Subject: AP1000 Standard COL Technical Report Submittal of APP-GW-GLR-044, Revision 1 (TR-85)

APP-GW-GLR-044, Revision 1 (TR-85), "Nuclear Island Basemat and Foundation"

Nuclear Island Basemat and Foundation

Road Map of Changes from Rev. 0 to Rev. 1 for TR85 (APP-GW-GLR-044)

Figure 2.6-2 (f) Comparison of Time History Response Spectra against 'ASB 60.5' envelope

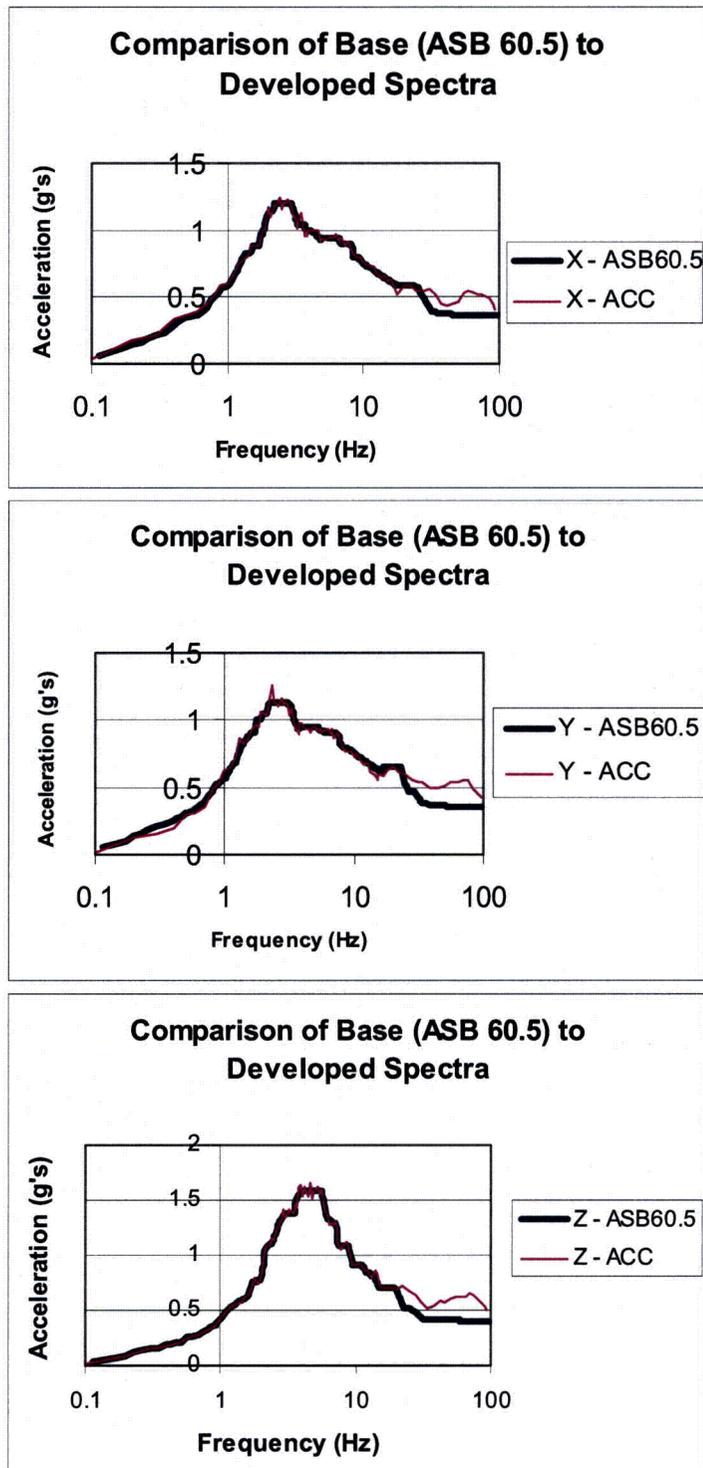
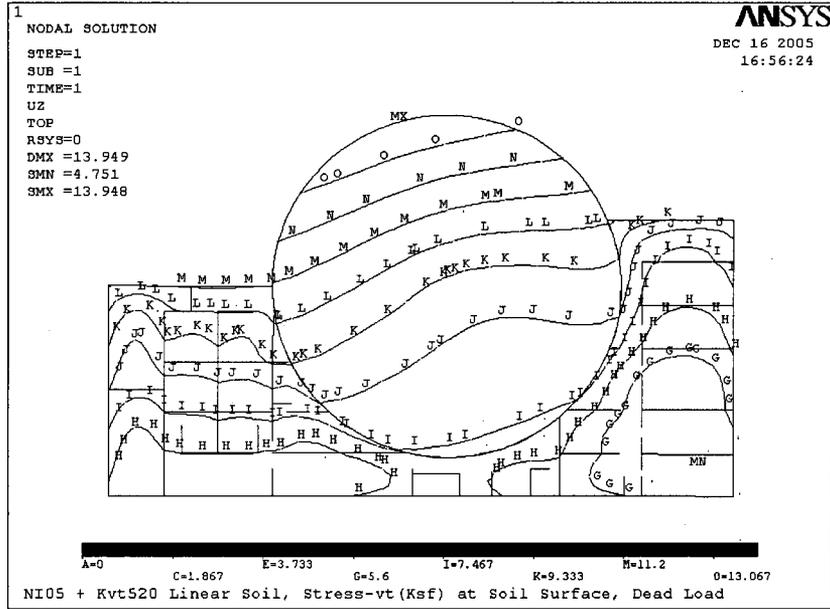
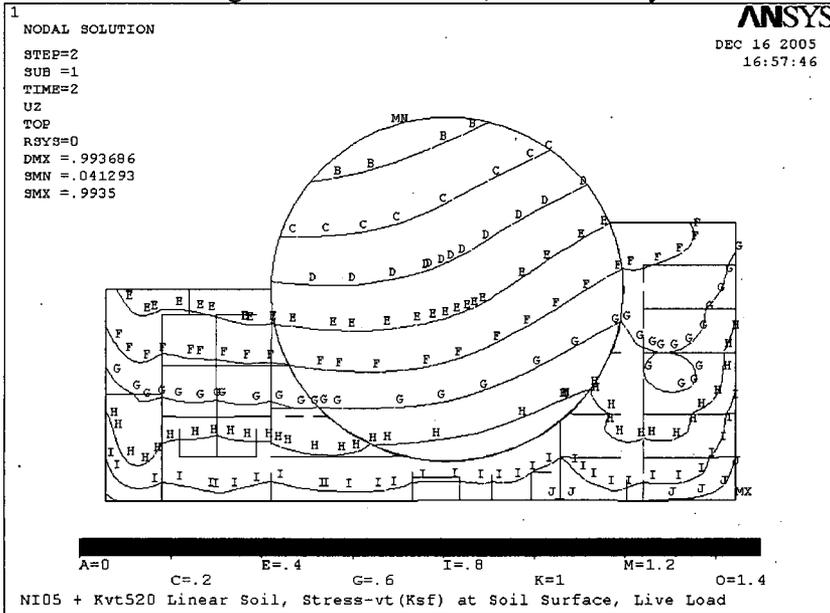
17	Table 2.6-2	<ul style="list-style-type: none"> Created Table 2.6-2 (a), Equivalent Seismic Static Accelerations for Nuclear Island Basemat Analysis. Modified Table 2.6-2 to 2.6-2 (b) by: <ul style="list-style-type: none"> deleting Time History values for "Hard Rock" and "2D Analysis" replacing with Fixed Base Time History Analysis (NI20, all soils) Created Table 2.6-2 (c), Maximum soil bearing pressures (ksf) at corners from basemat reactions. 	Changes presented in RAI-TR85-SEB1-22
18	Table 2.6-4	<ul style="list-style-type: none"> Expanded number of layers detailed in table 	Changes presented in RAI-TR85-SEB1-30
19	Figure 2.6-2	<ul style="list-style-type: none"> Added parts to 2.6-2 (): <ul style="list-style-type: none"> 2.6-2 (a) Section View of NI05 Model from East 2.6-2 (b) Section View of NI05 Model from North 2.6-2 (c) Typical Connection of Auxiliary Building Dish 2.6-2 (d) Connection Nodes between of Containment vessel and Dish 2.6-2 (e) Basemat response spectra from SASSI analyses 2.6-2 (f) Comparison of Time History Response Spectra 	Changes presented in RAI-TR85-SEB1-22

Figure 2.6-9 Radial Reinforcement, Top side of DISH

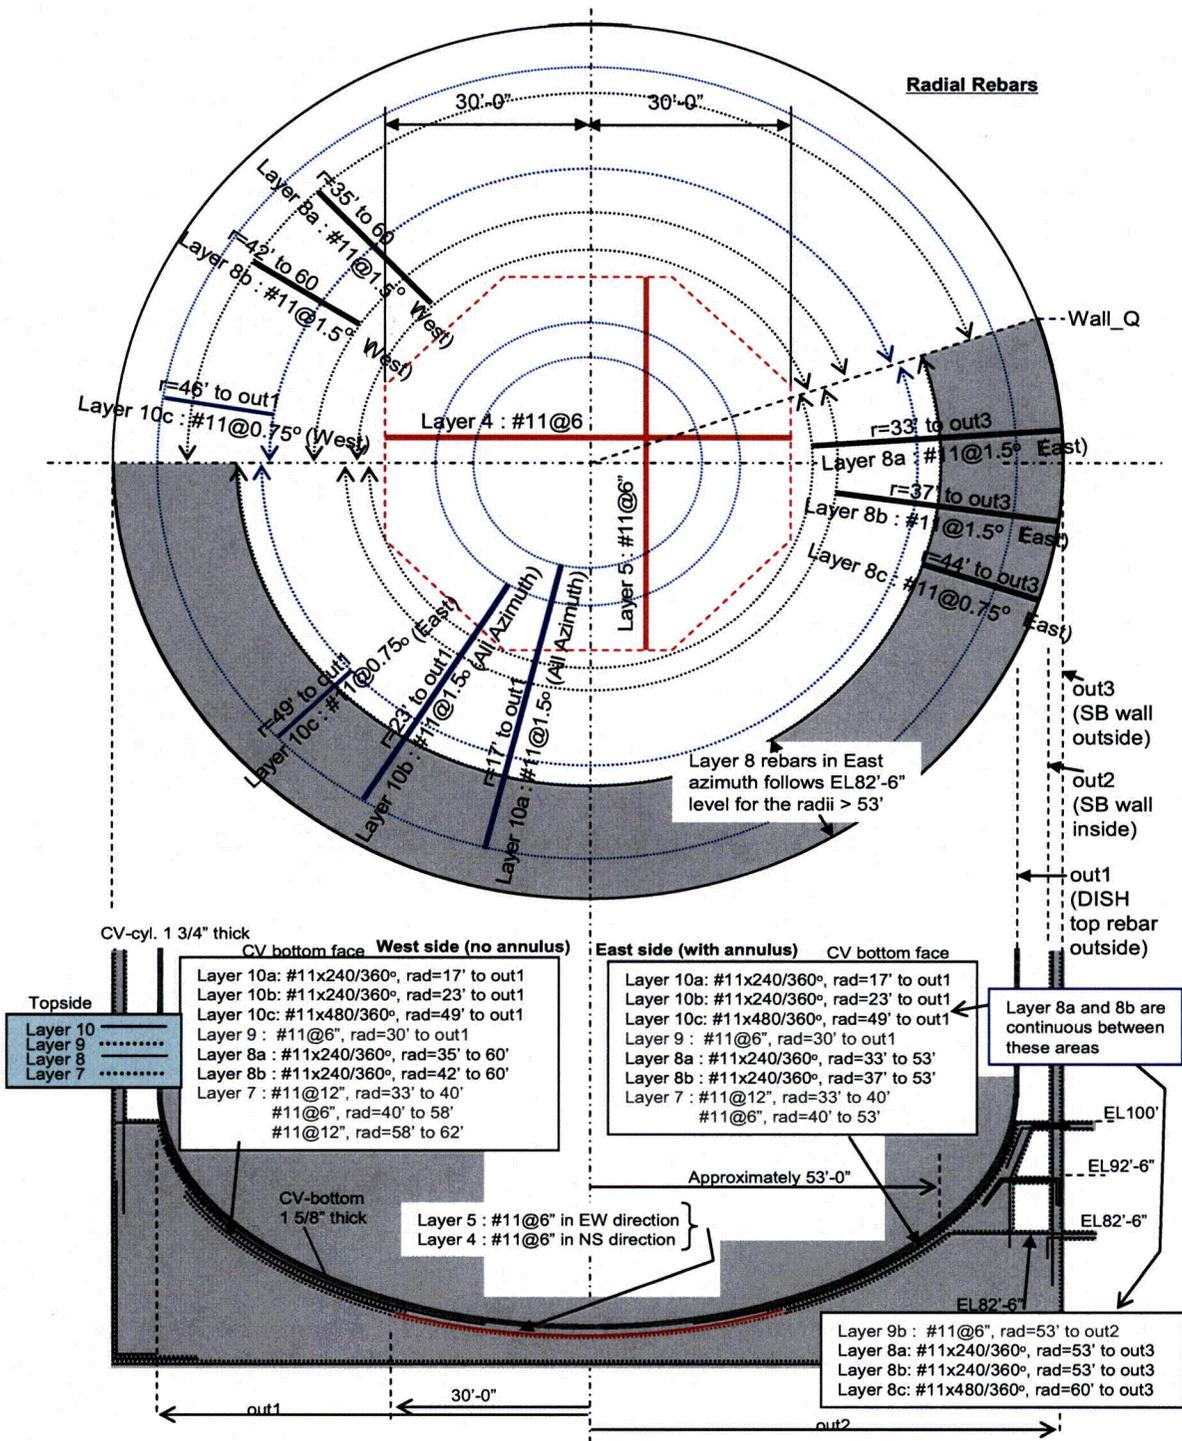
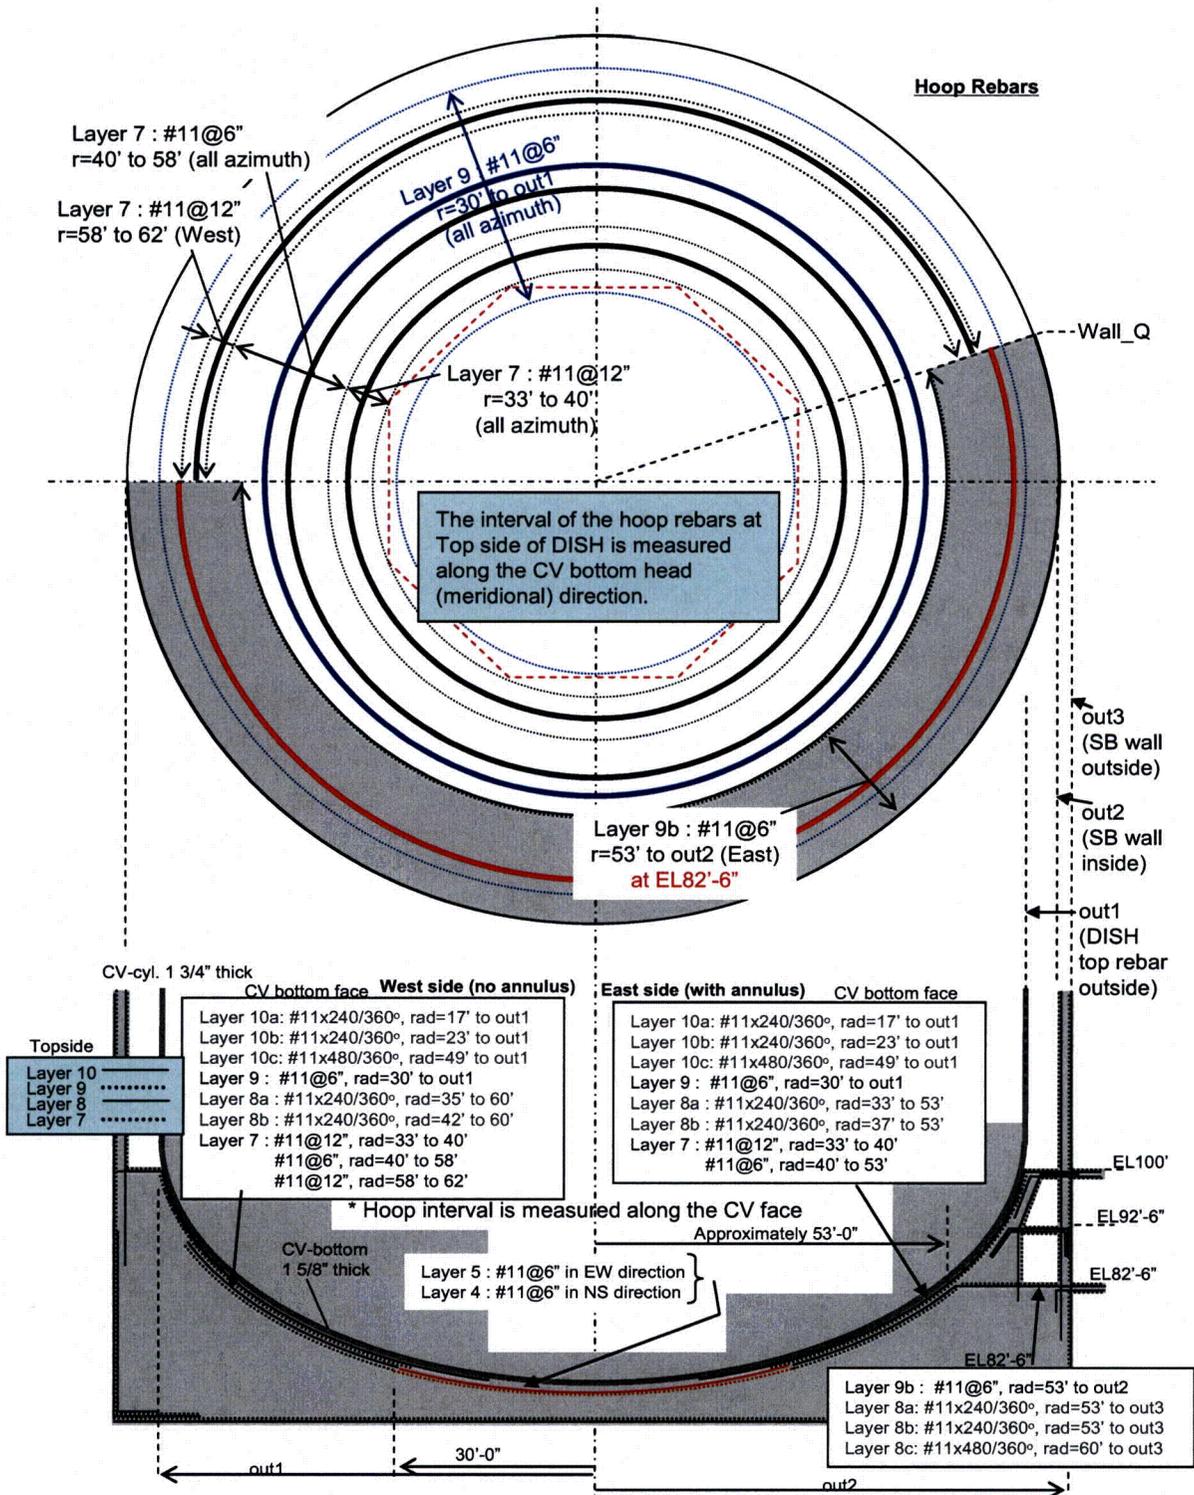
Item	Rev. 0 Section Number	Change in Rev. 1	Reason for Change
		against "ASB 60.5" envelope	
20	Figures 2.6-9 and -10	<ul style="list-style-type: none"> Modified to reflect changes in Table 2.6-4 	Changes presented in RAI-TR85-SEB1-30
21	2.9 Nuclear island stability	<ul style="list-style-type: none"> Added new 1st and 2nd paragraphs as per RAI-04 Various revisions to 4th paragraph as per RAI-10 	Addresses revisions and deletions as presented in RAI-TR85-SEB1-04 -10 and -34.
22	Table 2.9-1	<ul style="list-style-type: none"> Revised factors of safety for SSE Event and modified notes 	Changes presented in RAI-TR85-SEB1-10
23	Table 2.9-2	<ul style="list-style-type: none"> New table, Factors to Apply to Hard Rock Analysis Base Reactions 	Presented in RAI-TR85-SEB1-04
24	Figures 2.9-1 and -2	<ul style="list-style-type: none"> New figures, <ul style="list-style-type: none"> -1, Passive Pressure versus Deflection at Grade (North-South Excitation) -2, Passive Pressure versus Deflection at Grade (East-West Excitation) 	Presented in RAI-TR85-SEB1-10
